Subject: Official Notice No. 73

New Chase and High Rise Upgrades  
Police Administration Building  
749 West State Street  
Milwaukee, Wisconsin

Addendum No. 4

SHEET NUMBER: A105.X01

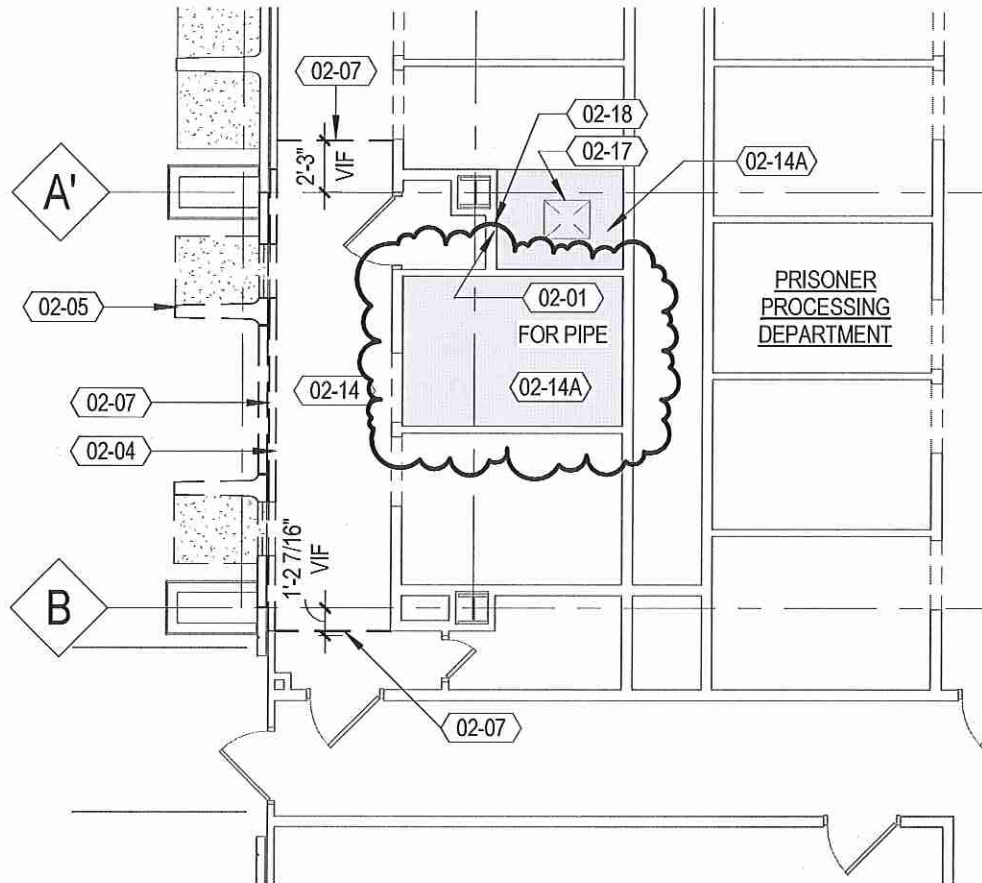
- **Sheet A105**

**MODIFY** amount of existing steel security ceiling to be removed and salvaged (by others) per clouded area on **attached sheet A105.X01**
